US.1 PEDESTRIAN OVERPASS STUDY

January 26th, 2000
July 7th, 2000 - Revised

RE: City of South Miami, Pedestrian Overpass
At South Dixie Highway (US-1) near Sunset Drive

The City of South Miami US 1 Pedestrian Overpass Study - Comments

C1.00

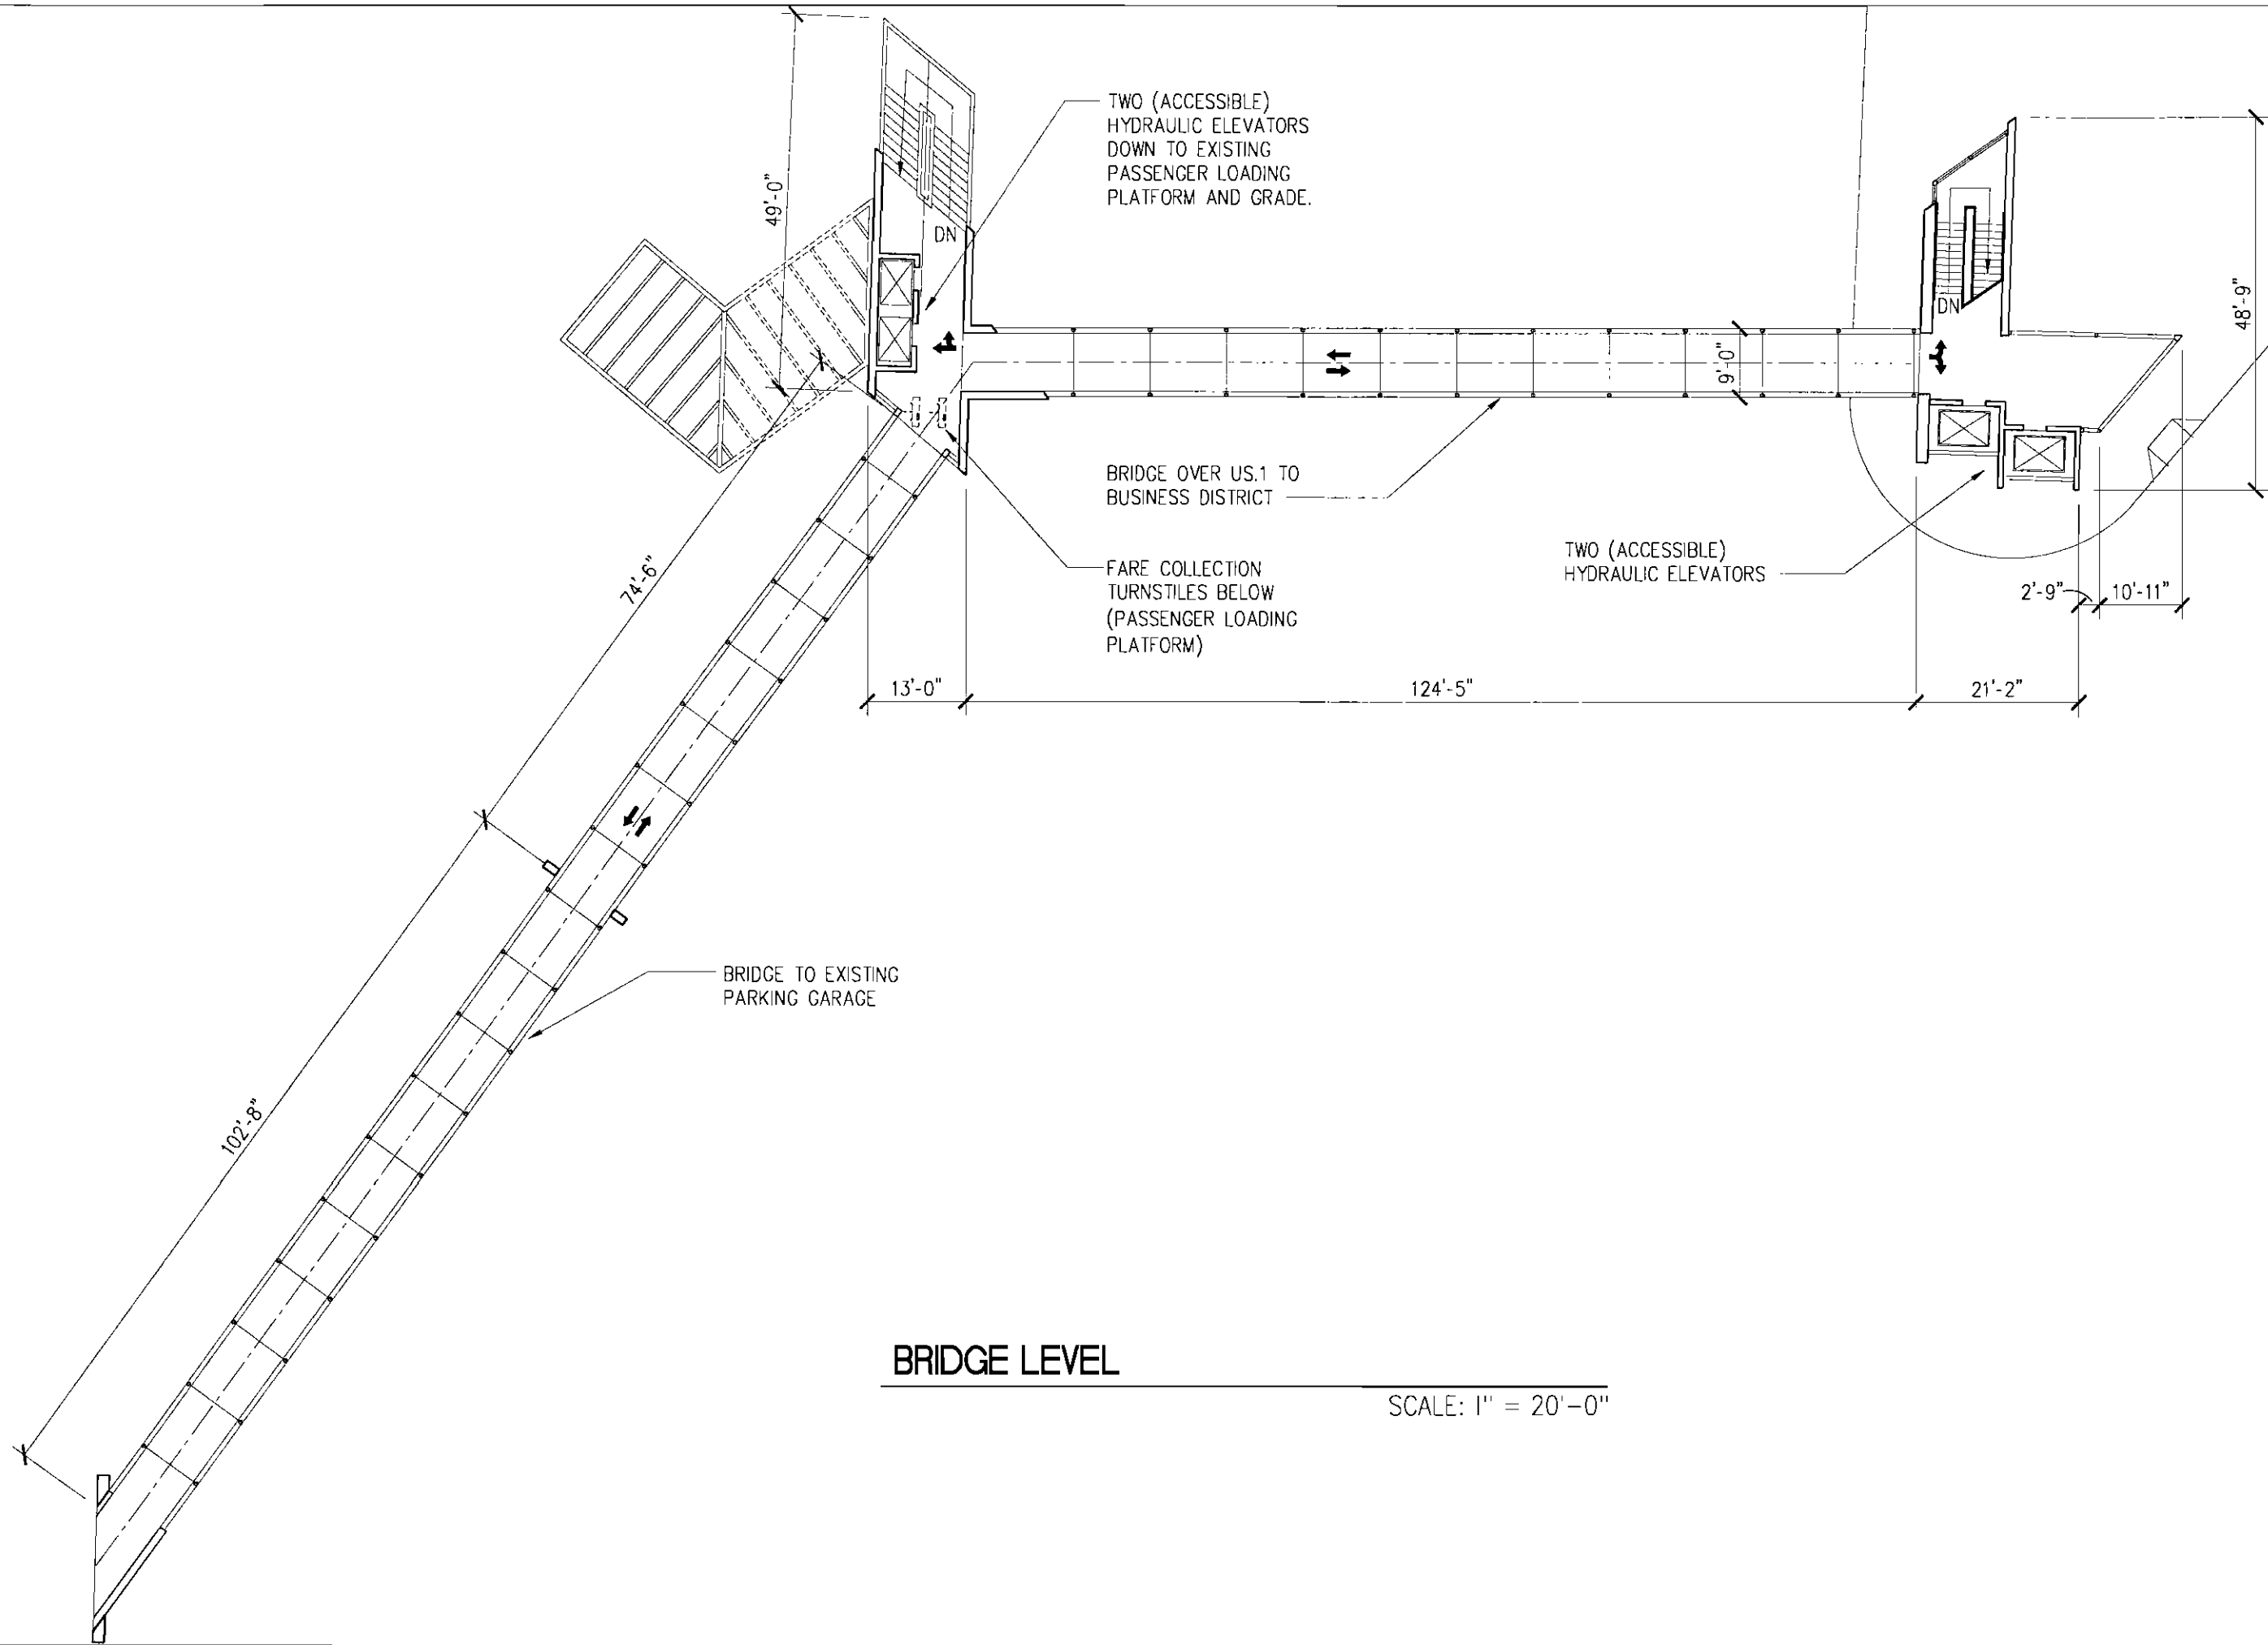
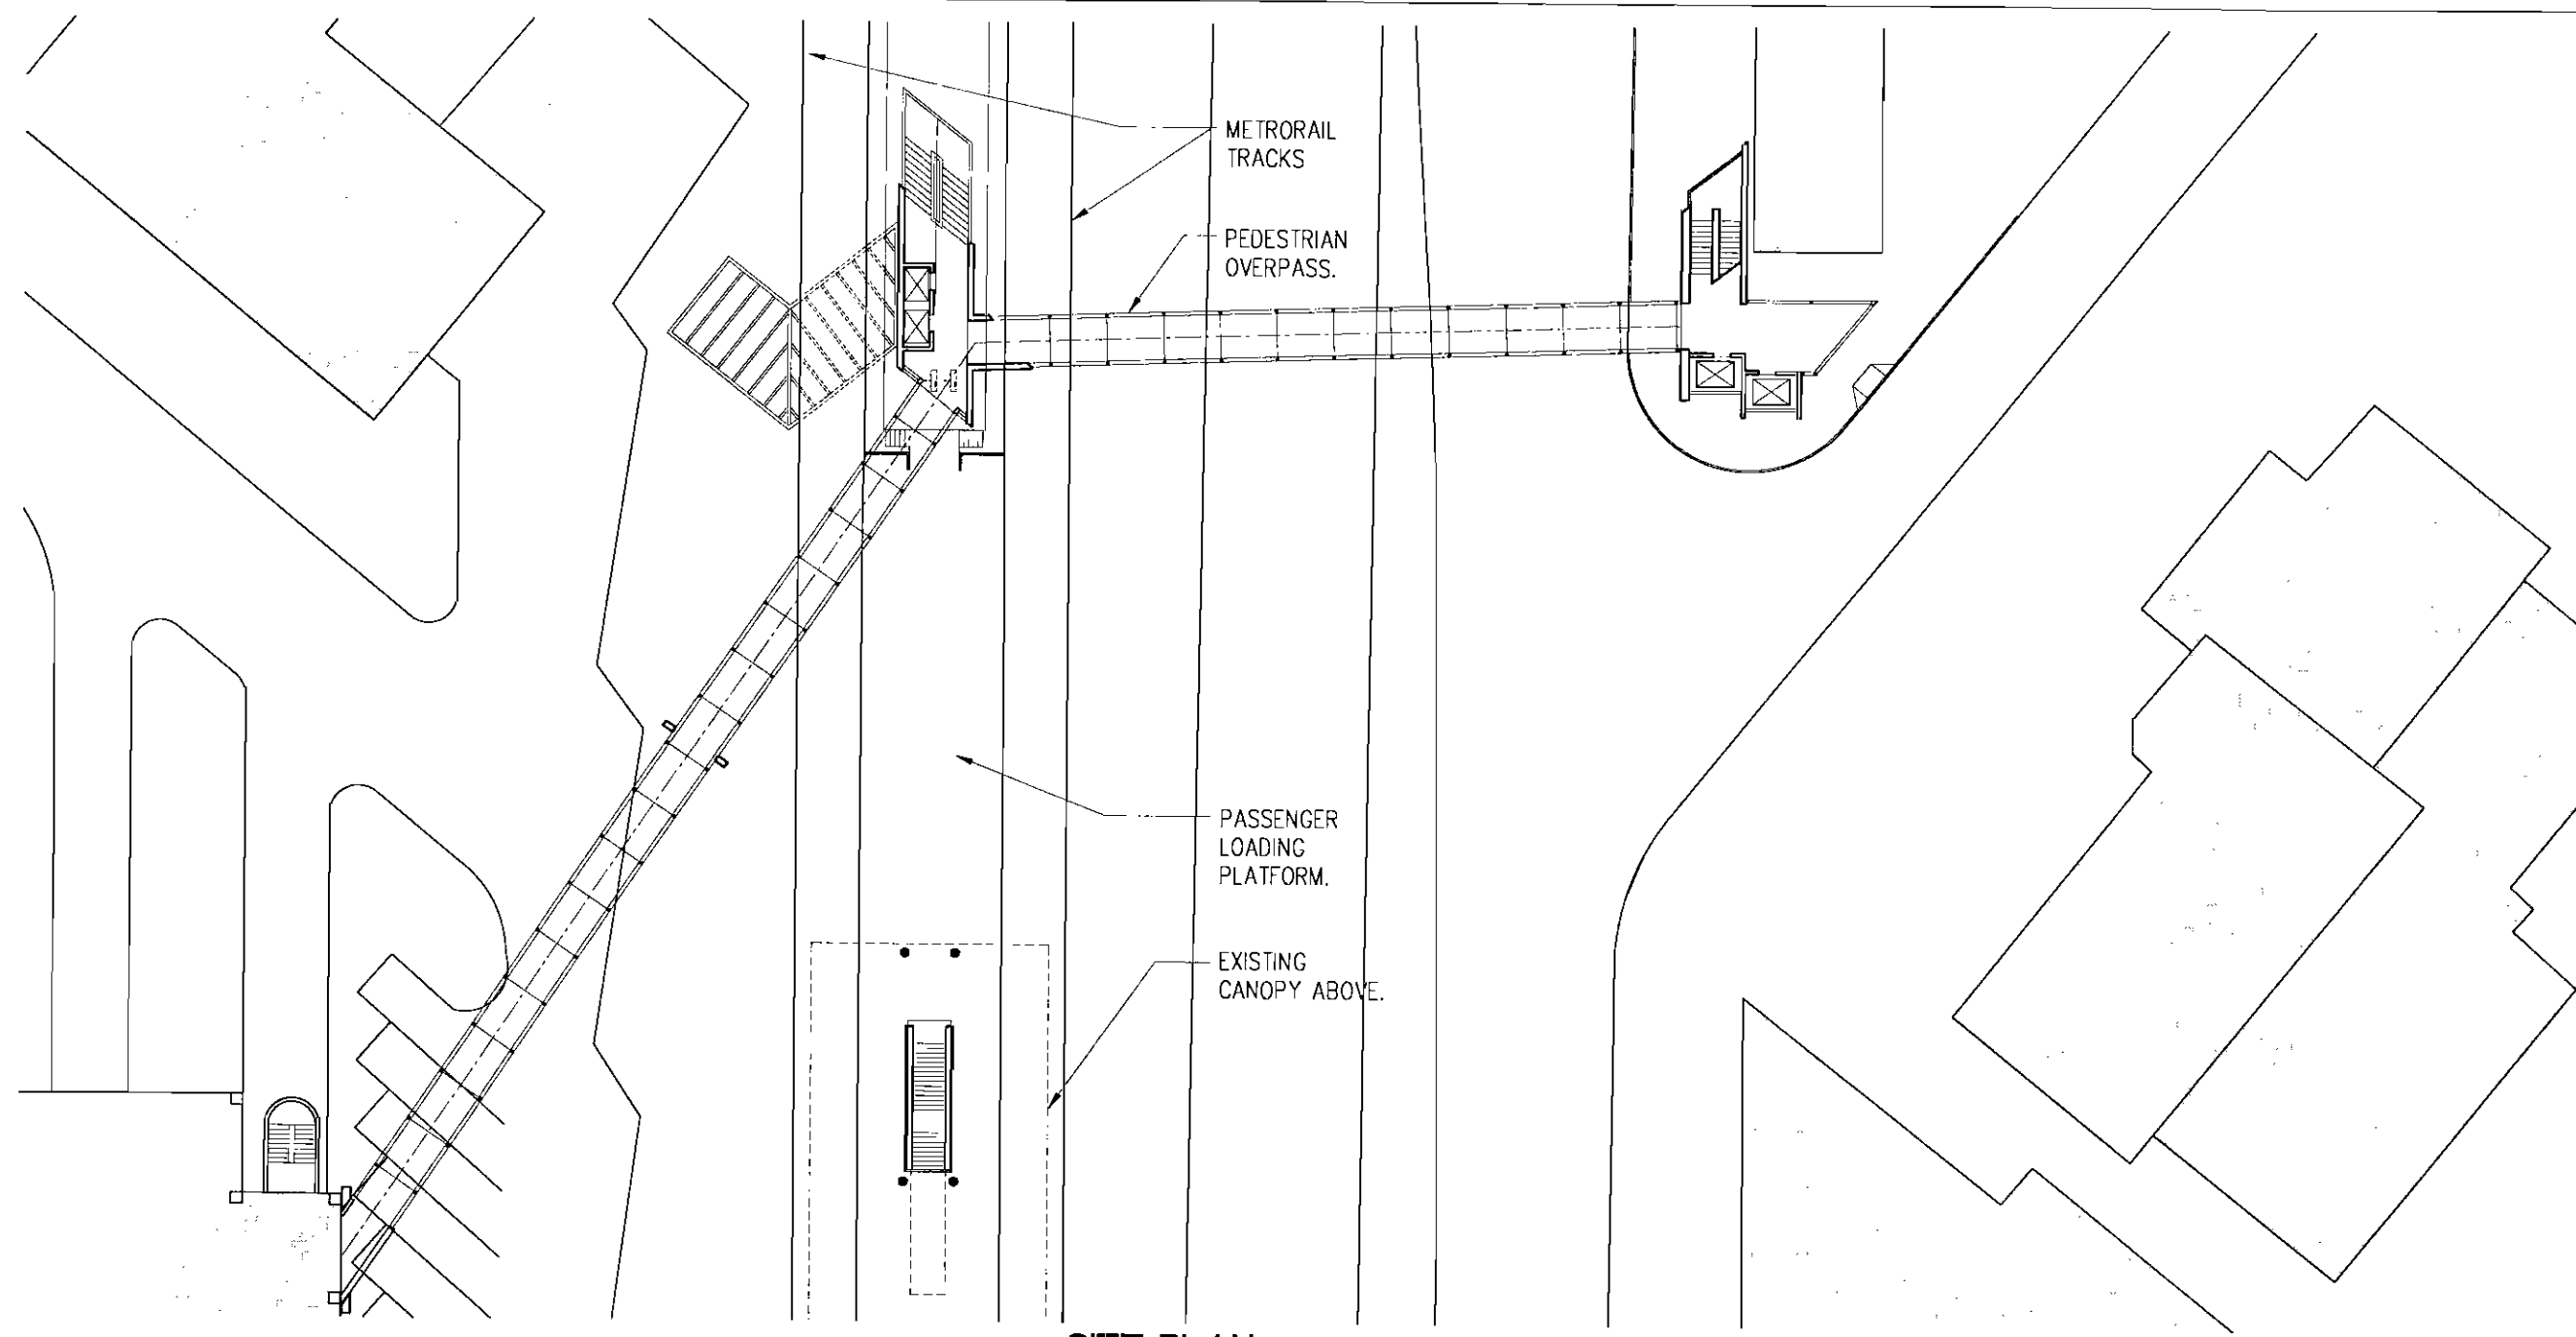
- Scheme "C" in Sheet A-3 does not appear to meet FDOT required horizontal clearance at the center support. In addition, we foresee a major disruption of traffic on South Dixie Highway during the construction of this center support. We recommend that this scheme or any others with intermediate support in the median of South Dixie Highway, are not considered in your study.

p. 8 Scheme C - Paragraph 1 says that the bridge will require support in the US 1 median. I believe that is an error, since the schematic for C does not show that, nor do I remember any mention of it during any meeting or discussion.

Figure 2.10.4 Clearances

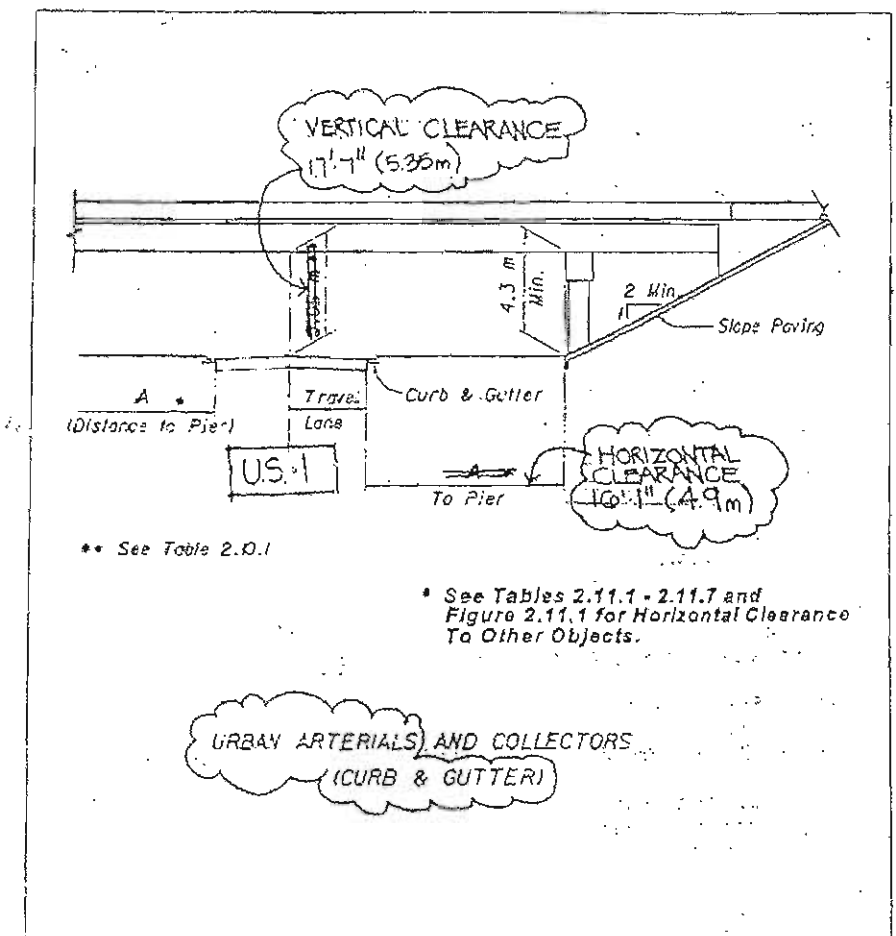
- Minimum vertical clearance 5.35m (17'-7") Table 2.10.1
- Minimum horizontal clearance 4.9m (16'-1") Table 2.16.6

Please review the attached sketch illustrating these clearances and make any necessary comments or corrections.

With reference to your memo of 3/15, please be advised that the clearance criteria shown therein is correct.

THE CRITERIA SHOWN ABOVE IS CORRECT. PLEASE FIND THE ATTACHED COPY OF CHAPTER 14 OF THE STRUCTURES DESIGN GUIDELINES FOR YOUR INFO. IN MY OPINION, THE APPROACH RAMP IS REQUIRED FOR CHILDREN AND HANDICAPS OR SENIOR CITIZEN. A COMBINATION OF STAIRS AND ELEVATORS SHOULD DO THE JOB.
